City of Portland, Maine – Building or Use Permit Application 389 Congress Street, 04101, Tel: (207) 874-8703, FAX: 874-8716

Location of Construction: 142 Bear Reed Ave Peaks Island		Owner: Joanne Fiore		Phone: 878-2319		Permit No: 000151	
Owner Address: 29 Deepwoods Dr. Portland		Lessee/Buyer's Name:		Phone:		Business Name:	
Contractor Name: ** Horizon Builders inc.		Address: ** 12 May Street Portland ME 04101		Phone: 879-9787		Permit Issued: MAR 2	
Past Use: single family		Proposed Use: same		COST OF WORK: \$ 82,715.96		PERMIT FEE: \$ 522.00	
				FIRE DEPT. <input type="checkbox"/> Approved <input type="checkbox"/> Denied		INSPECTION: Use Group: Type:	
				Signature:		Signature:	
Proposed Project Description: add second story and covered porch to single story home				PEDESTRIAN ACTIVITIES DISTRICT (P.A.D.) Action: Approved <input type="checkbox"/> Approved with Conditions: <input type="checkbox"/> Denied <input type="checkbox"/>			
Permit Taken By: K.		Date Applied For: Feb 23 2000 K

BUILDING PERMIT REPORT

REASON FOR PERMIT: Add second story and covered porch to single home.

FIORE CAMP
PEAKS ISLAND, MAINE
SCALE: 1/4" = 1'-0"
BY: TWC DATE: 2-12-01

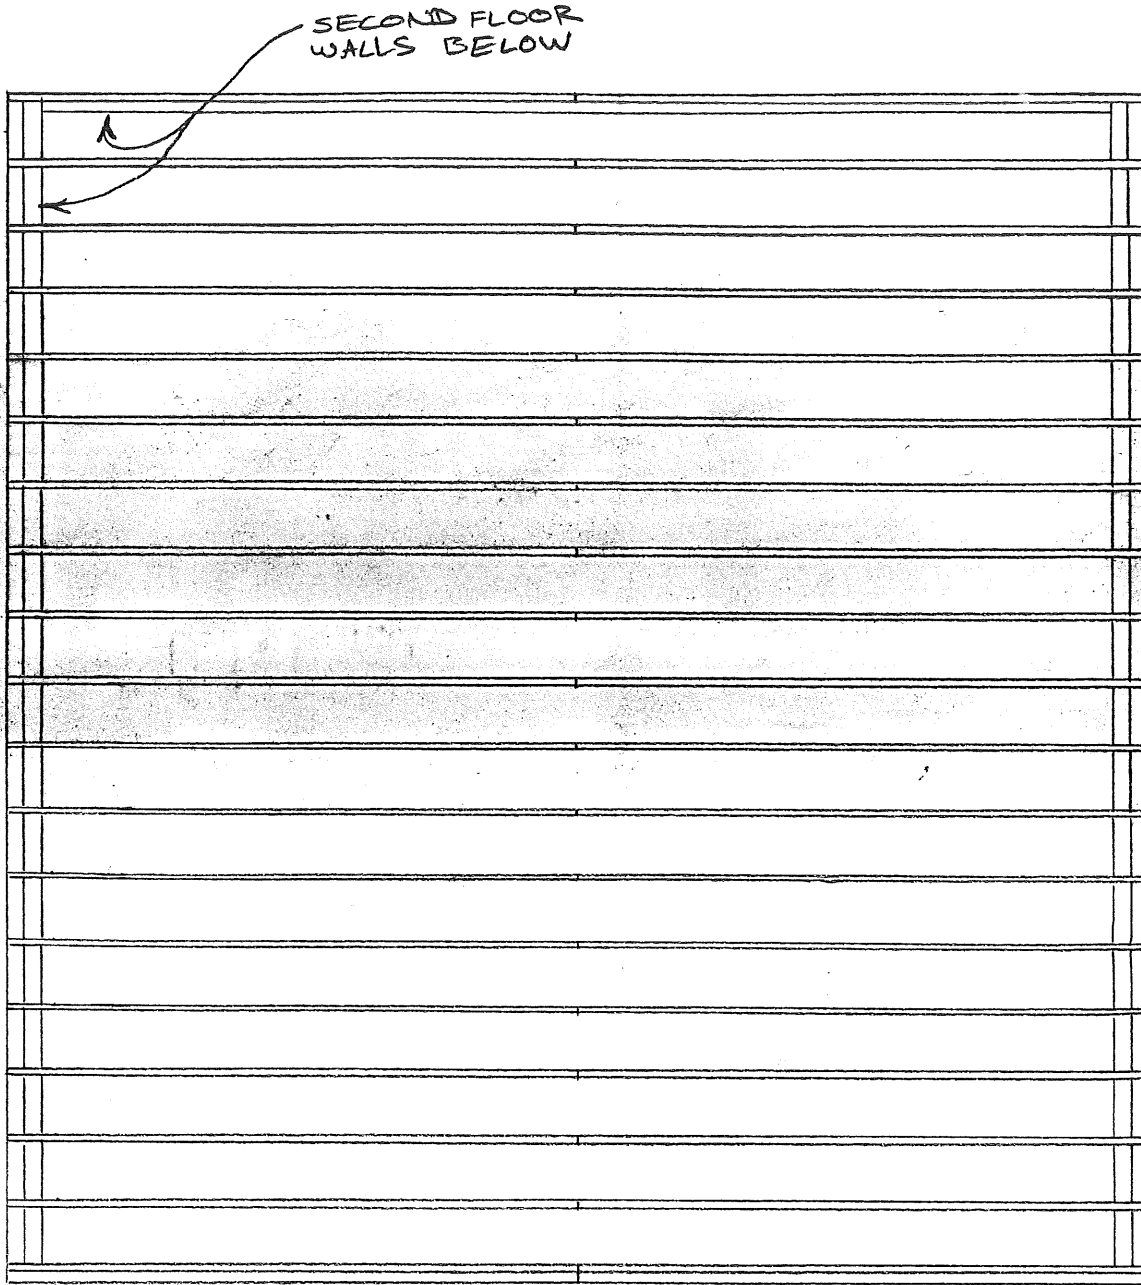
Egress windows - section 1 & 4
